NSA-122jlq  
EA99-013

This letter is to request additional information regarding NHTSA's investigation of crash-induced fuel filler neck assembly failure in 1996 through 2000 DaimlerChrysler NS-minivan vehicles. As you know, a second NHTSA crash test of a subject vehicle has resulted in a failure of the fuel filler neck assembly. On January 6, 2000, a left-side impact test (NHTSA No. MY0303) of a 2000 Dodge Caravan for NHTSA's New Car Assessment Program (NCAP) resulted in the fuel filler neck hose separating from the fuel tank spud and most of the tank contents spilling onto the ground.

Figure 2 Fuel tank and filler pipe

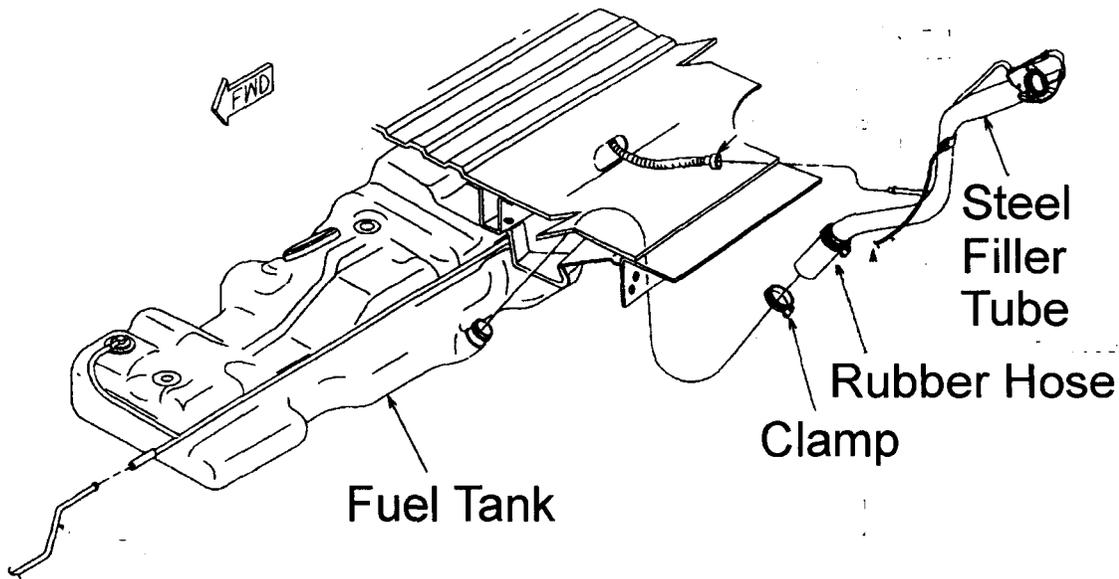
**System Description:** The subject filler neck assembly is routed from the filler door through the forward portion of the left-rear wheelhouse. A plastic liner covers the assembly in the wheelhouse. The assembly extends forward from the bottom of the wheelhouse, through a space between the inner sill wall and the left rail structural member, to the fuel fill and vent fittings of the fuel storage tank (See Figure 1). The tank is mounted inboard of the left rail structural member forward of the rear axle. The filler neck assembly consists of the fuel filler tube and the fuel tank vent tube. A 5-inch long rubber hose (painted green in Figure 1) connects the steel filler tube (yellow) to a 1.6 inch, inner diameter high-density polyethylene (HDPE) nipple or spud (orange/red) on the side of the tank. The hose extends over the spud about 1¾ inches and over the steel tube about 1¾

inches. The rubber hose is secured to the filler tube and tank spud by standard worm drive type hose clamps (see Figure 2).

Several aspects of DaimlerChrysler's design of the filler neck assembly for the subject minivans contribute to an overall lack of robustness in the design to withstand either a high tensile load or significant displacement input during a moderate to severe crash. This is confirmed by NHTSA's evaluation of data collected from other manufacturers of minivans (NHTSA sent peer information request letters to five other manufacturers to obtain information about their filler neck assembly designs). For example, the rubber hose connected to the fuel tank inlet is significantly shorter than the hose on other peer minivans (giving rise to higher tensile load for a given amount of displacement), and the bead on the tank spud (which provides resistance to pull-off force) is ramped with a shallower angle than peer minivans. The location of the filler neck assembly and the surrounding vehicle structure does not isolate the filler neck from crash forces as well as other minivans. For this reason, the filler neck assemblies of some other minivans will experience less loading and displacement on the filler neck during a crash. Also, DaimlerChrysler did not reinforce the tank spud on the subject minivans with a metal liner, as some other manufacturers did on their minivans, which would have reduced compression deformation of the tank spud during high tensile loading. Finally, DaimlerChrysler does not have performance specifications for the minimum pull-off force of the rubber hose from the filler pipe or fuel tank spud as do some other minivan manufacturers, and the company did not test the capability of the hose to withstand such a force during development of the subject minivans.
